41ST STREET APARTMENTS

DESIGN REVIEW RECOMMENDATION

DPD #3013699

DEPARTURE MATRIX

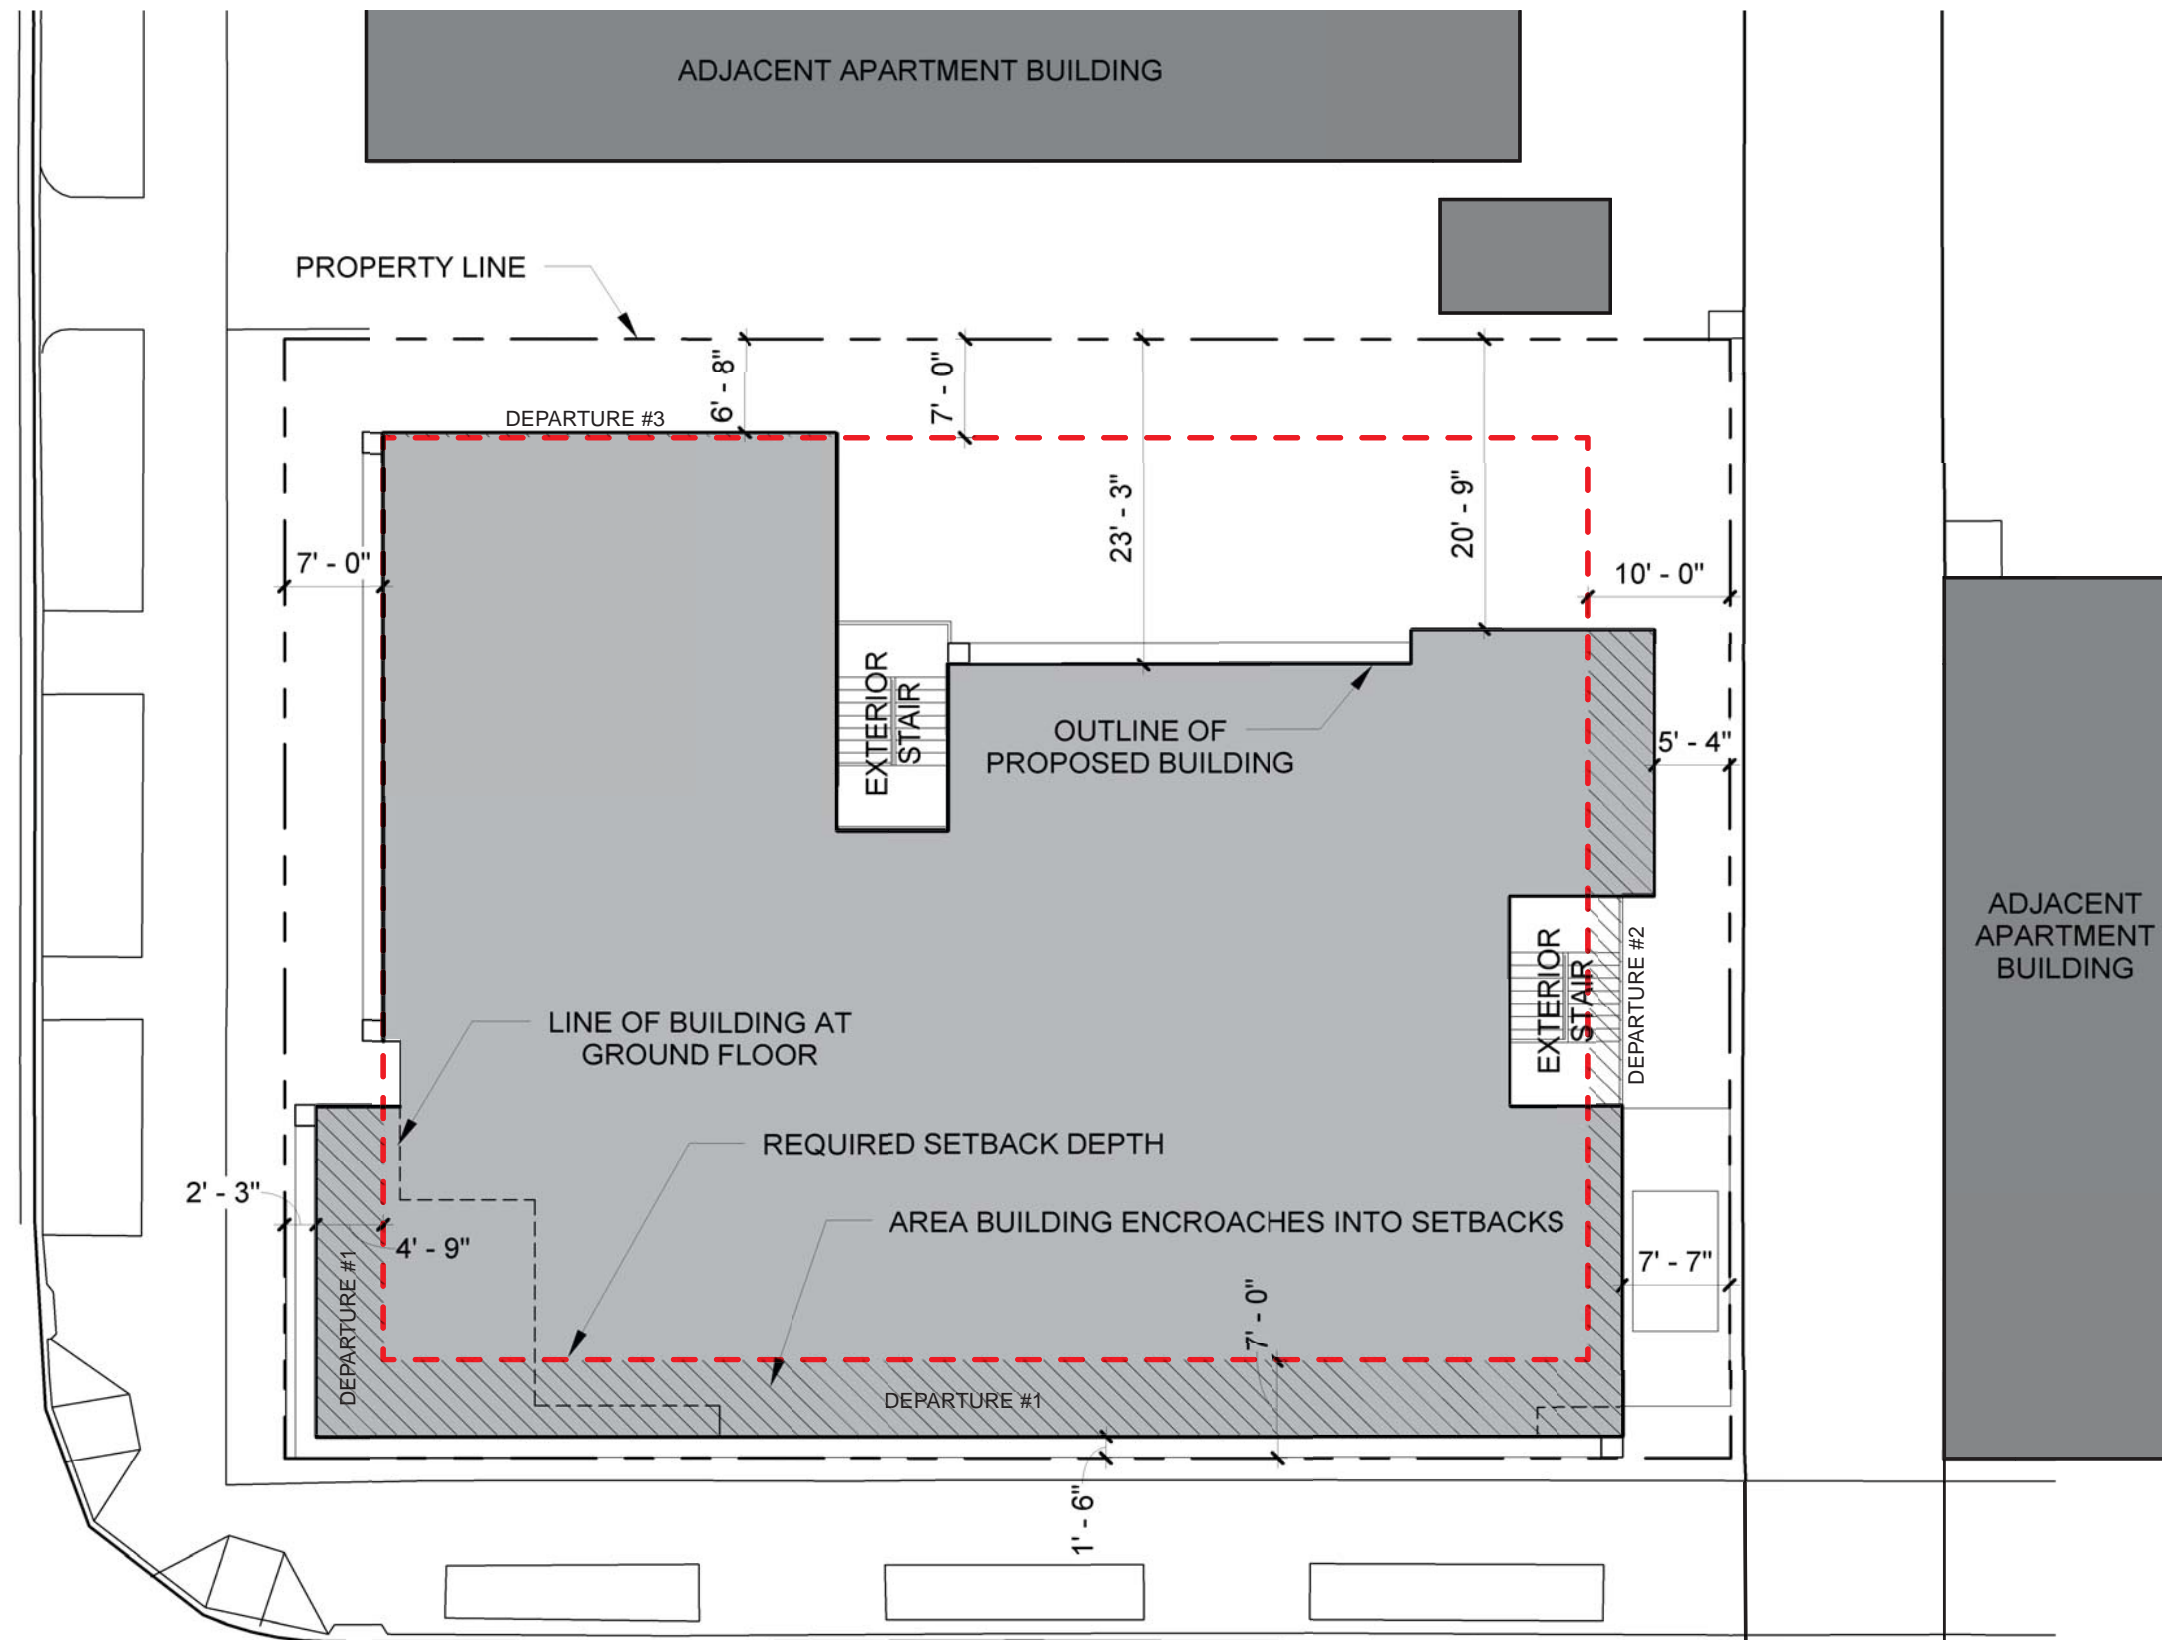
MR ZONING CODE	REQUIREMENT	PROPOSED	DEPARTURE AMOUNT	REASON FOR DEPARTURE	DESIGN REVIEW GUIDELINES
#1 FRONT SETBACK SMC 23.45.518	5'-0" minimum & 7'-0" average. 0' for projects with a courtyard 20' deep and 30% of the street frontage.	<p>Minimum yard fronting NE 41st Street:</p> <ul style="list-style-type: none"> - Upper Floors: 1'-6" minimum, 1'-6" average - Ground Floor: 1'-6" minimum, 3'-10" average <p>Minimum yard fronting 12th Ave NE:</p> <ul style="list-style-type: none"> - Upper floors: 2'-3" within 25' of lot corner at street intersection, 7' for the remainder of the frontage (5'-6" average) - Ground Floor: 7' minimum, 9'-5" average, (exceeds code minimum) not including structural column at corner. 	<p>Along NE 41st Street:</p> <ul style="list-style-type: none"> - Upper Floors: 3'-6" from minimum, 5'-6" from average - Ground Floor: 3'-6" from minimum, 3'-2" from average <p>Along 12th Ave NE:</p> <ul style="list-style-type: none"> - Upper Floors: 2'-9" from minimum within 25' of lot corner at street intersection, no departure for the remainder of the frontage (1'-6" departure from average) - Ground Floor: no departure, not including structural column at corner. 	<p>The intersection of 12th Ave NE and NE 41st St. is dominated by the two new UW dormitory buildings at two corners and Condon Hall on the 3rd. The recently completed dorm buildings are characterized in part by being massed directly at the back of walk, in many cases with no front yard setback. At some points along the street front facades, the buildings stepback 2' to 3' at the lower floors to provide for planting strips and glazed storefronts at building entries. While these projects are located on MIO zoned parcels, they do create a precedent along NE 41st Street for a strong building wall that is slightly recessed at certain points to create an interesting streetscape.</p> <p>This design proposes a similar building massing. Along NE 41st Street, the upper floors will extend out to the street edge, while the lower floors will be recessed to provide for landscaping and raised residential decks. Most notably, a covered entry court is provided at the corner of NE 41st and 12th Ave NE to create a prominent building entry. Moving away from the intersection along 12th Ave, the building is setback 7' to respect the character of the properties to the north and to meet the regular provisions of the code.</p>	A-2 Streetscape A-7 Open Space B-1 Height, Bulk, Scale D-1 Pedestrian Space E-2 Landscaping

#2 REAR SETBACK SMC 23.45.518	10'-0" minimum from rear alley property line	<ul style="list-style-type: none"> - 7'-7" within 40' of NE 41st Street frontage (following 1'-0" alley dedication) - 5'-4" for remaining 19' of building 	<ul style="list-style-type: none"> - 2'-5" for first 40' of alley frontage - 4'8" for remaining 19' of building 	<p>This departure request is related to Departure #1 in that the request is related to creating a building massing that is comparable to the newly constructed UW Dormitory buildings and other buildings in the immediate area. To create a strong building massing along the street edge, we are requesting that the building massing extend to within 7' of the lot line fronting the alley. Both the UW dormitory buildings and the brick building located directly across the alley do not setback from the alley lot lines, creating a strong precedent for building walls continuously along the street edge. The 7' building setback within 40' of the street would allow for a proper sight triangle for vehicles existing the alley, landscaping and some relief for the corner units of the adjacent brick building.</p>	A-2 Streetscape B-1 Height, Bulk, Scale

#3 SIDE SETBACK SMC 23.45.518	<p>For portions 42'-0" high or less: 5'-0" minimum and 7'-0" average</p> <p>For portions higher than 42'-0": 7'-0" minimum and 10'-0" average</p>	<ul style="list-style-type: none"> - For portions 42'-0" high or less: 6'-8" within 40' of the 12th Ave NE property line, and 20'-9" or greater for remainder of side yard. Average setback is 12'-10". - For portions higher than 42'-0": 6'-8" within 40' of the 12th Ave NE property line, and 20'-9" or greater for remainder of side yard. Average setback is 12'-10". 	<ul style="list-style-type: none"> - For portions 42'-0" high or less: no departure from minimum, no departure from average - For portions higher than 42'-0": 0'-4" from minimum, no departure from average 	<p>For most of the north façade, the building maintains a generous average setback of 12'-10", much greater than the minimum requirements of the code. There is only a small portion of the north façade that infringes into the side setback. In shaping the massing of the building at the north property-line, a generous courtyard is provided that creates space and greenery between the adjacent buildings and improves the overall project design. The footprint of this building with all the setback requests is still less than the footprint of a code compliant building. Setback requests such as this one have been used to shape the building so that it better responds to site opportunities.</p>	A-7 Open Space B-1 Height, Bulk, Scale

DEPARTURE RATIONALE

As mentioned in the departure matrix on the previous page, allowing the proposed building to be massed along the street edge in combination with the corner entry plaza and recessed ground floor, would respond to the character established by the adjacent UW dormitories. MR zoning does allow for a 0' front yard setback when a street-facing courtyard is provided, with the courtyard providing a sense of relief along the street edge. The covered entry plaza and recessed ground floor provides a similar sense of relief close to grade while the upper floors project out overhead in response to the nearby context.

A benefit of this approach is the increased sideyard setback that is created along the northern property line. Rather than a 7' wide sideyard with limited use, the proposed project would create a generous landscaped courtyard space for the use of all building residents. The approximately 32 units facing this sideyard would benefit from the added separation from the building to the north (as would the units in this adjacent building). In addition to the proposed roof deck, this ground-level courtyard would provide a second, differentiated outdoor common space with distinct features, such as deep planting, that could not be accommodated on a roof deck.

VIGNETTE SECTIONS

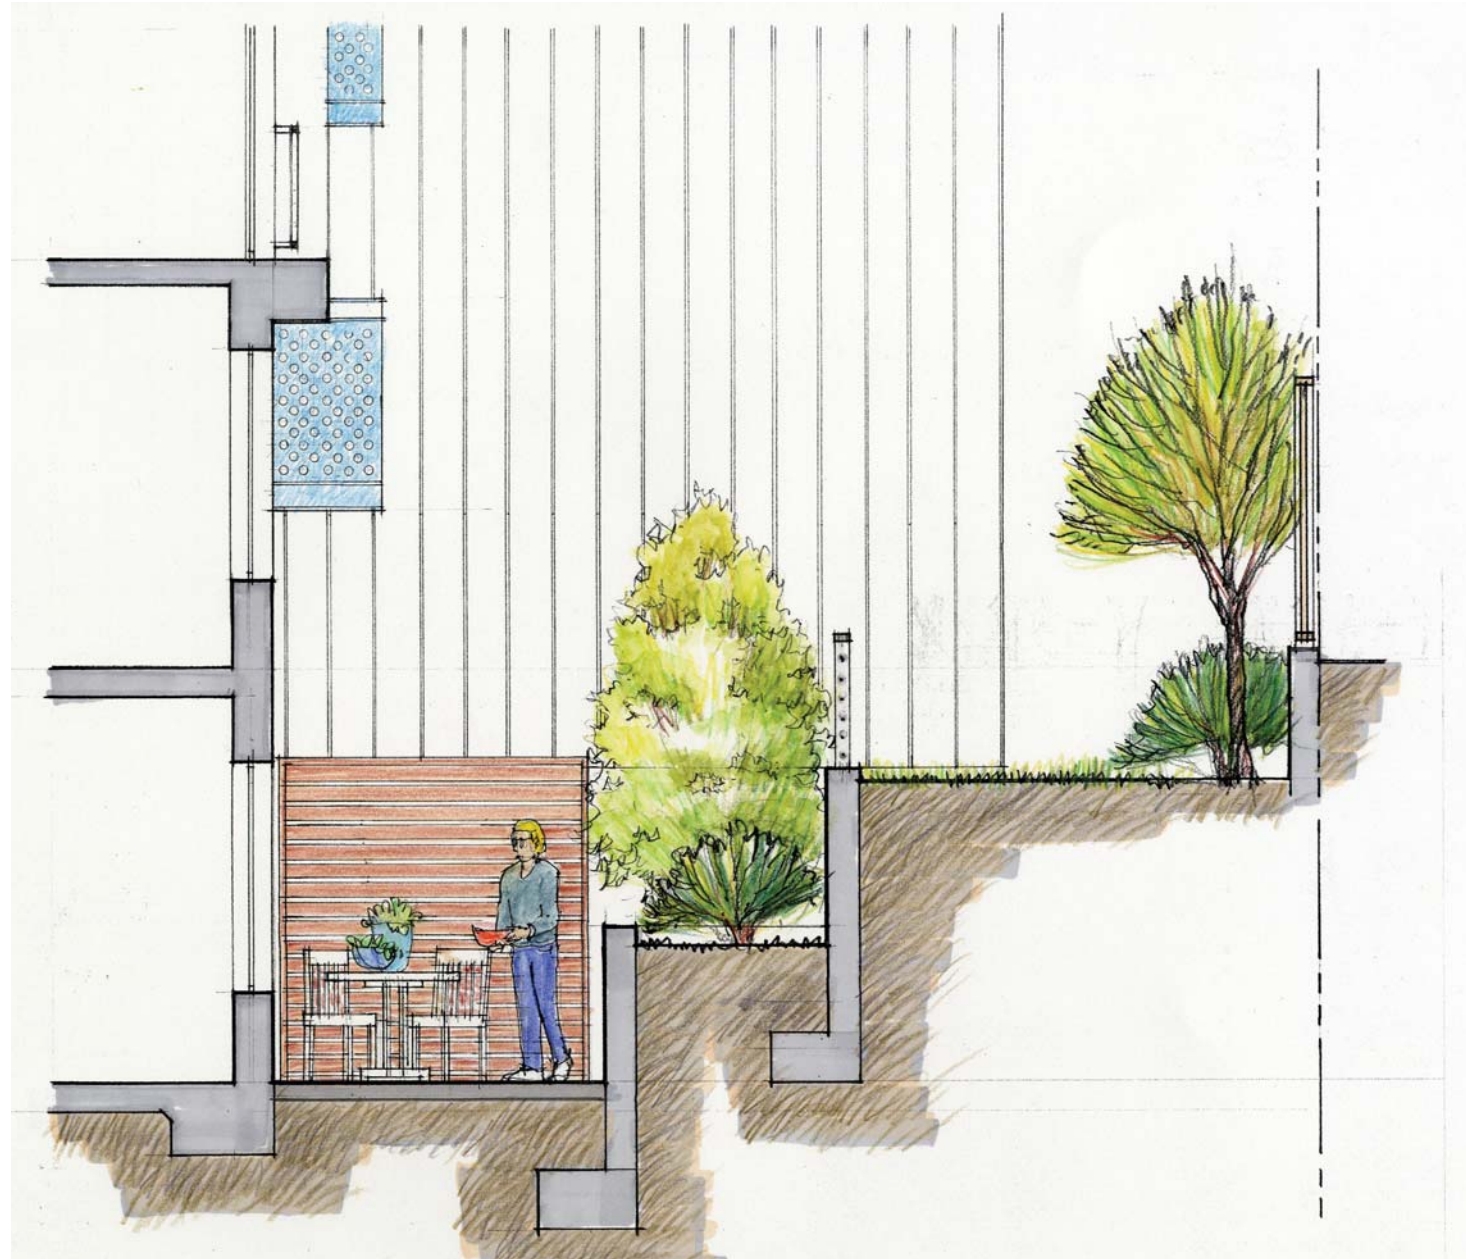
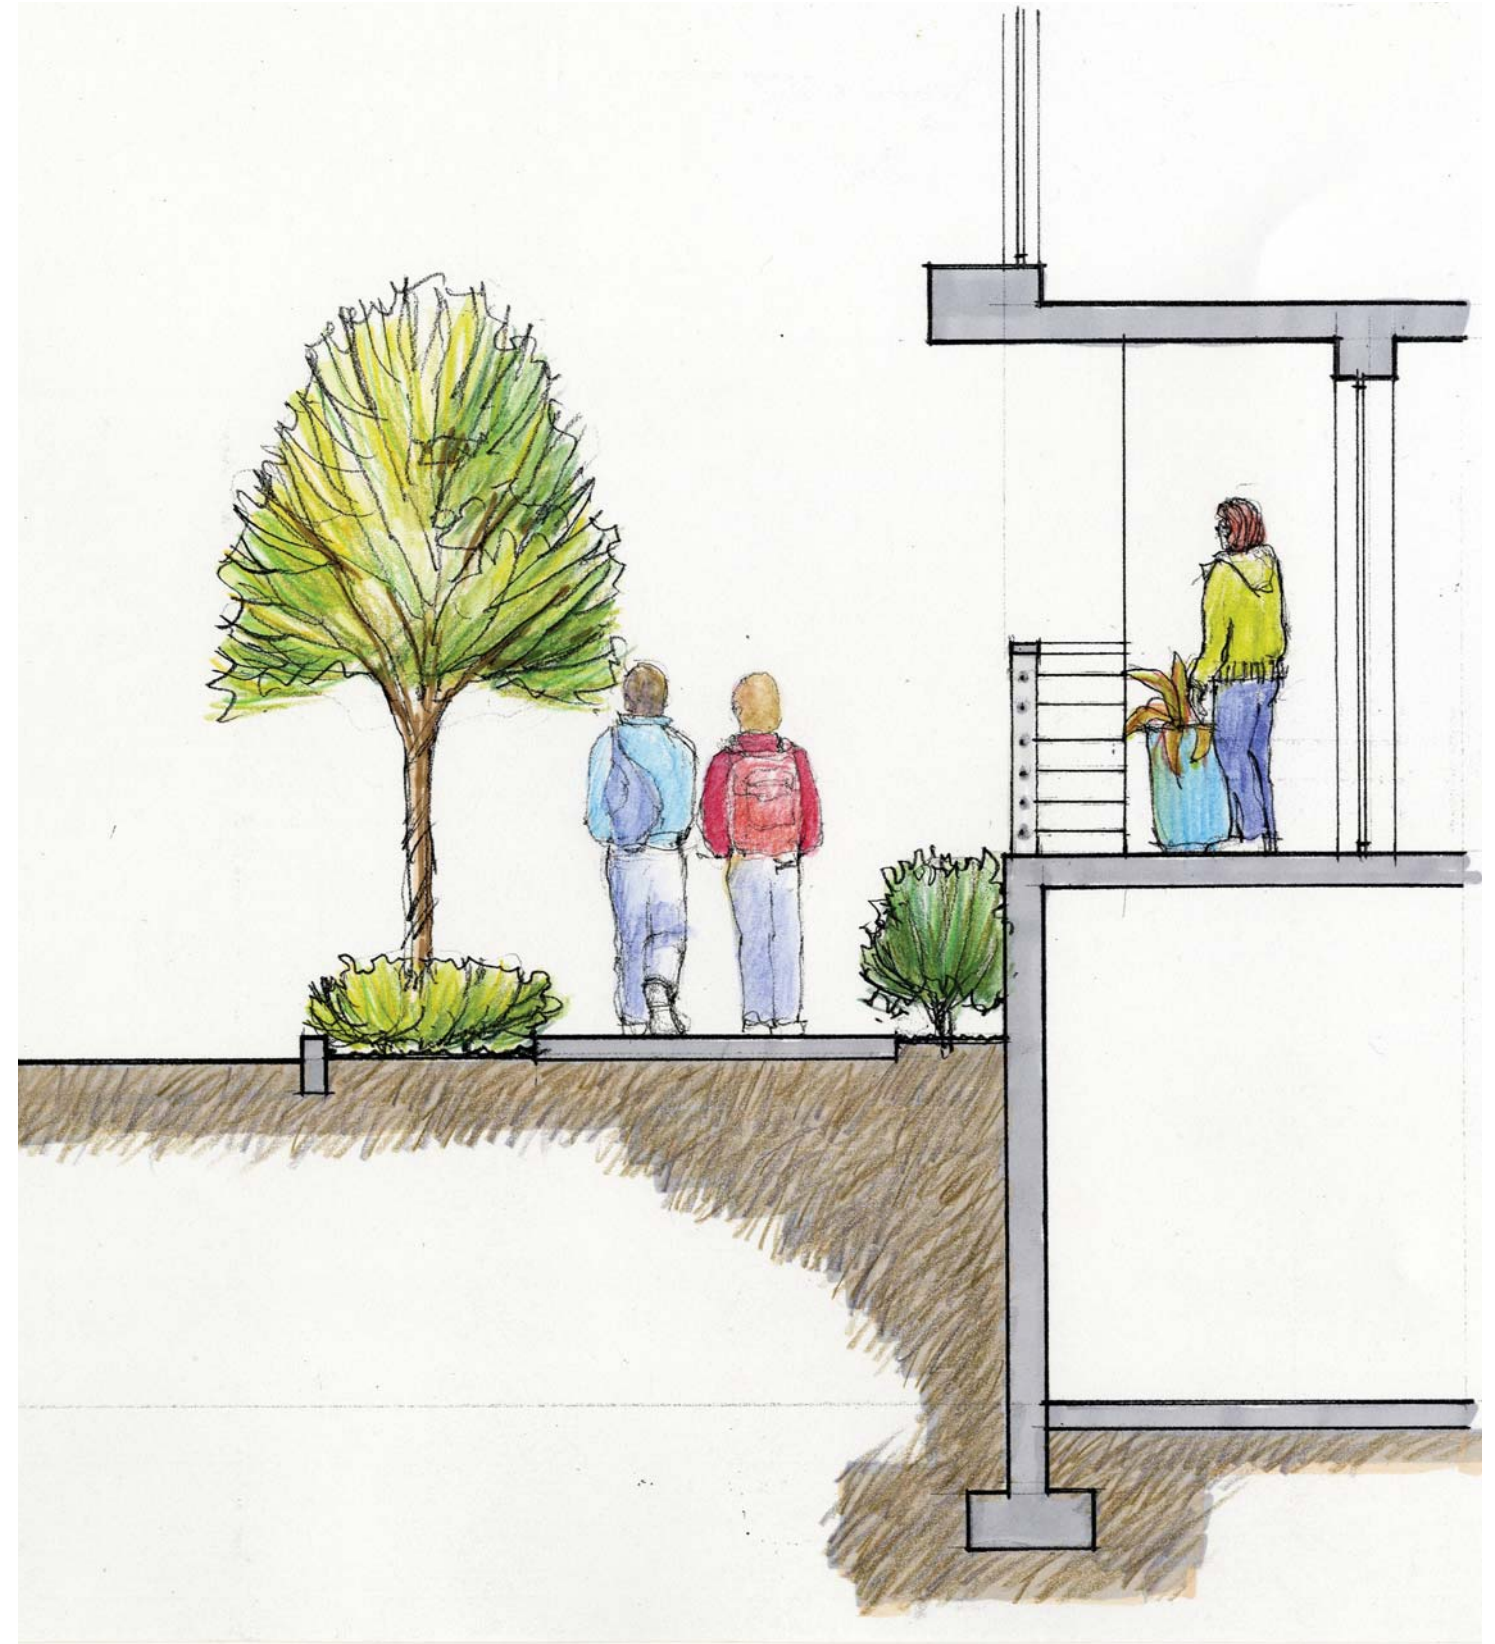
At the Early Design Guidance Meeting, the Board discussed this issue at length, and agreed that the raised decks are strongly preferable, as long as they include quality materials below and carefully designed railings that maintain "eye on the street". The Board was concerned that deep patios would appear as "moats", and advised these be changed to light wells or double height units with no cut into the ground plane. Detailed cross sections showing curb, sidewalk, landscaping and architecture should be provided at each typical patio condition.

Responding to the Board's concerns, the sunken units at 12th Avenue that required light wells have been removed and landscaping has been put in their place. The raised patios on 41st have been designed with cable rails that are highly transparent and avoid creating a wall at the street level. The attractive use of landscape serves both as a buffer zone between public and private zones.

The sunken units at the north courtyard have been addressed in the design as shown in the section and vignette provided in the DRB packet. Rather than using one tall wall between the patios and grade, two terrace steps are used. First the patio area at the property line is lowered in relationship to the adjacent neighbor and then a landscape terraced step is provided between this public patio area and the individual patios. This terracing, combined with a cable rail fence and landscaping open the sunken units up to both light and greenery.

LIGHTING AND AMENITY PLAN

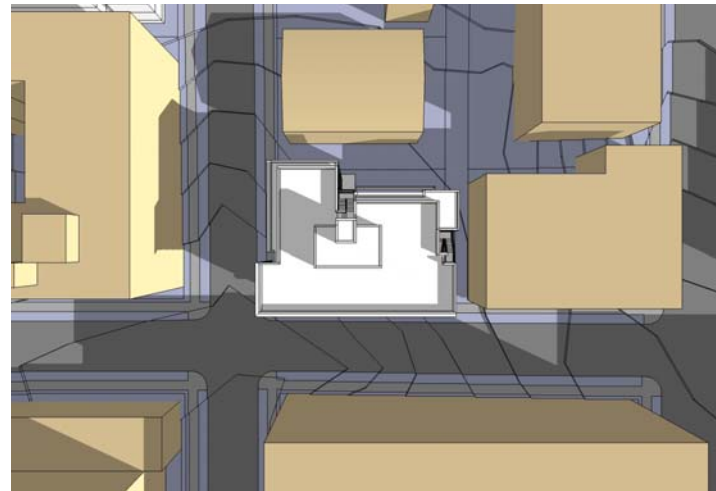
At the Early Design Guidance Meeting, the Board discussed how important lighting is; though this is not a commercial project, it is on busy student/pedestrian streets.

A lighting plan has been provided with the DRB packet that shows location of fixtures and is focused on provided security and lighting up important areas of the project such as the entry plaza.
